# DEVELOPMENT REVIEW COMMITTEE (DRC) COMMENT REPORT

**PROJECT NAME:** 730 NE 4th Ave Mixed Use Development

**CASE NUMBER:** UDP-S23055

**REQUEST:** Site Plan Level III Review: Conditional Use for Increased Building Height in the Urban Neighborhood Character Area for 77 Multifamily Units and 1,682 Square Feet of Commercial Use in Downtown Regional Activity Center

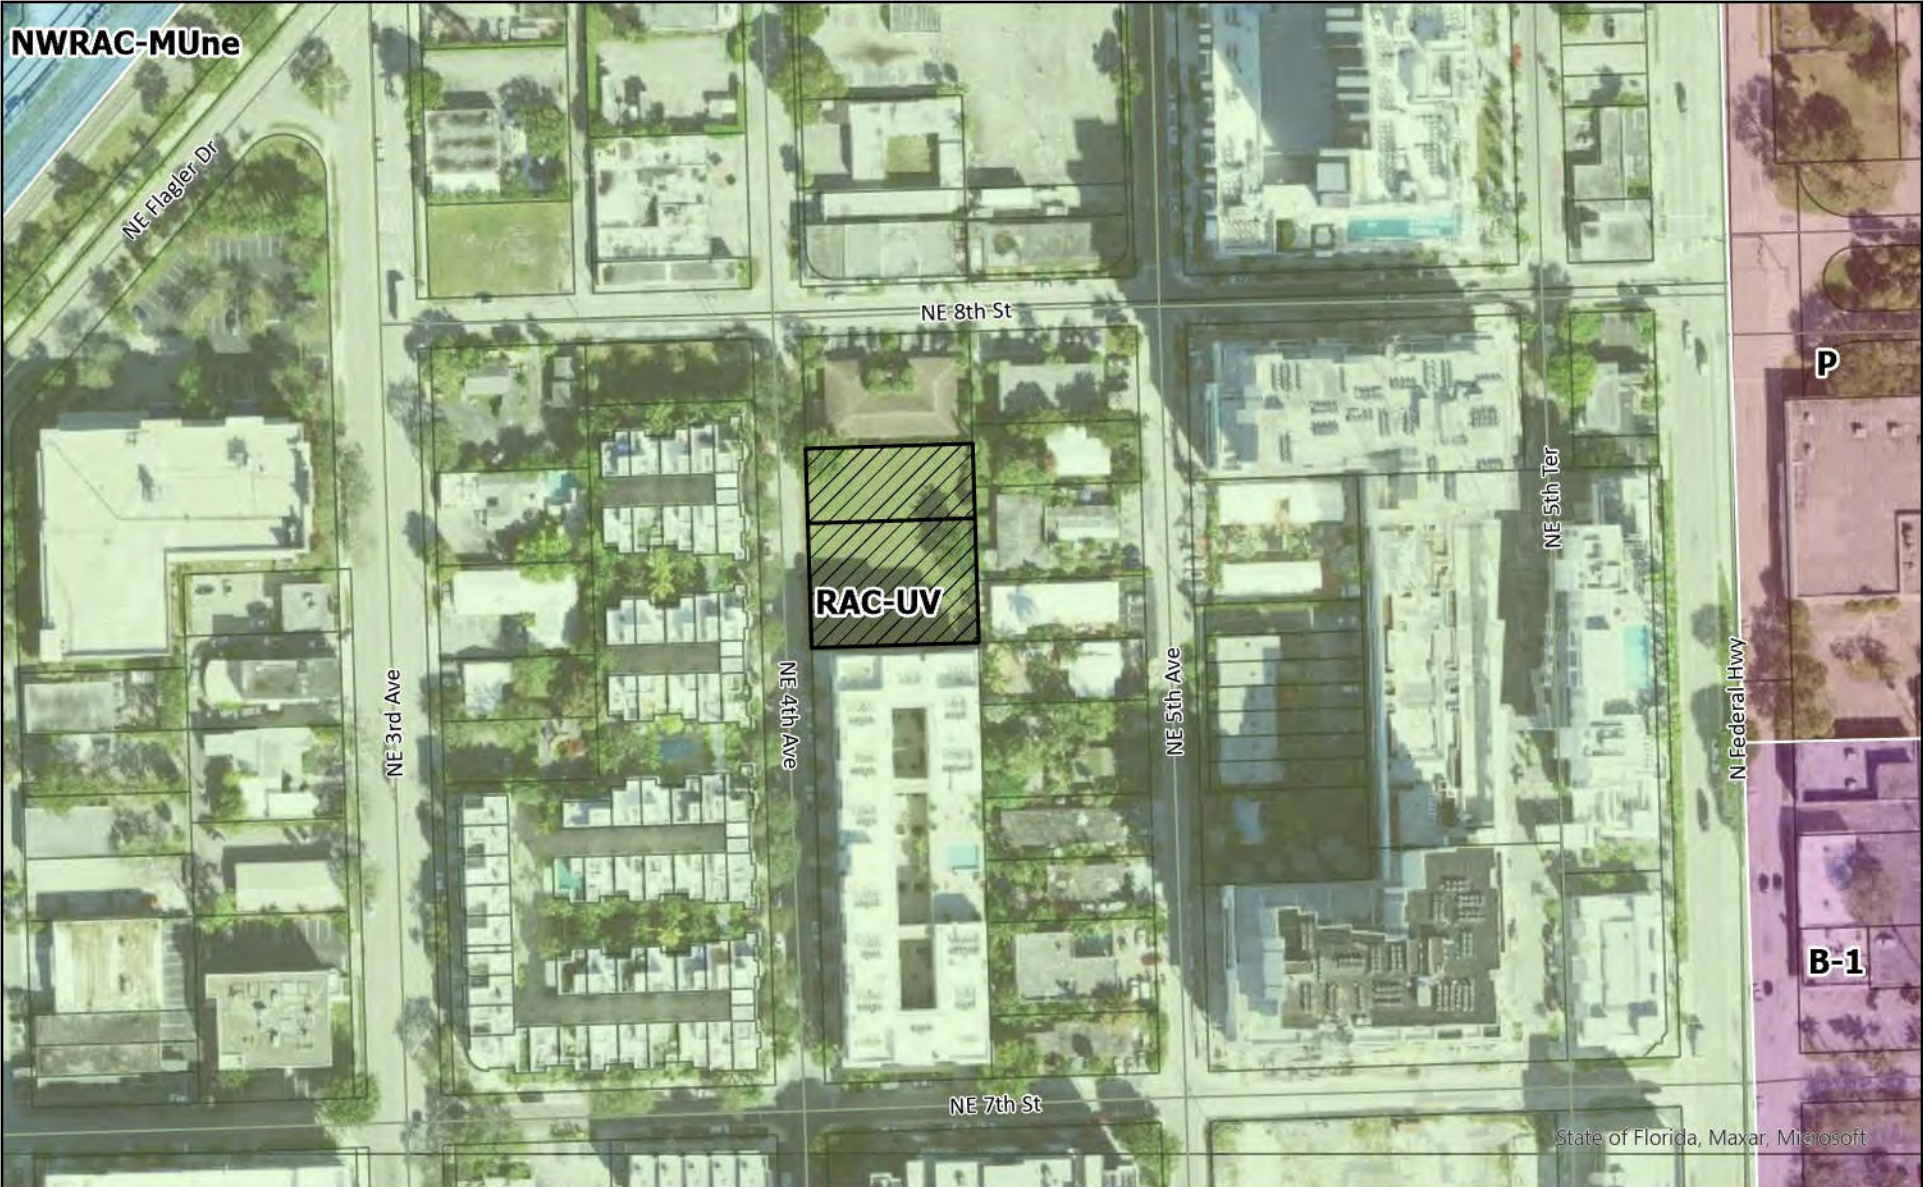
- Provide a design element more inclusive to the overall architecture instead of the use of arches and which is more interactive with the public realm, for example, provide a double height architectural feature with overhang at the lobby entrance to accentuate the entrance, and incorporate a public plaza around that feature. See images below for reference.

- c. Align the building setback with the building on the property to the south to create consistency streetwall along NE 4<sup>th</sup> Ave. For reference, both the multifamily project to the south and Alta Flagler Village Phase do not encroach within the 35-foot setback to centerline at all, providing a clear 15 foot setback. See images below for reference.
